Subject: New Ignition Relay

Application: Certain 1993 900 Models

New Ignition
Relay
450
(22B:C)

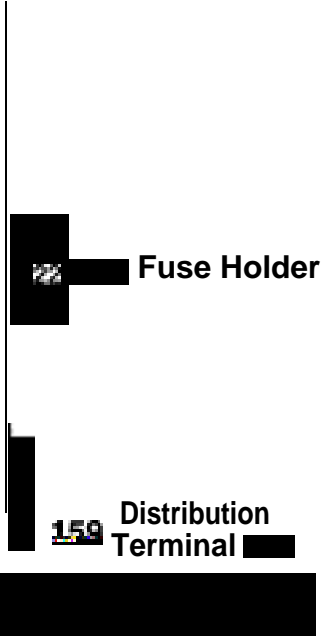
This new **relay**, fitted in position C of the main fuse box, cannot be found on existing wiring diagrams. Please see page two of this bulletin for an updated diagram. You might want to make copies of the wiring diagram to paste into your dealership's copies of Section 3-9 Electrical system, system diagrams, operation and fault tracing MI 991-92 Service Manual, P/N 03 44 028.

NOTE: Relay 450 can be added to position C of the relay panel on 1990 and later 900's but note that wire colors, numbers, etc. will vary. The object is to feed direct battery voltage to the ignition system and avoid any voltage drop that may be present in the existing wiring. The ██████████ wire is used to control the relay.

NOTE: Remove ██████ 1.0 wire number 546 from the █████ distribution terminal in the main fuse box and connect it to the fused side of fuse █████ This moves the █████ input for the LH ECM 200 from fuse █████ to fuse █████
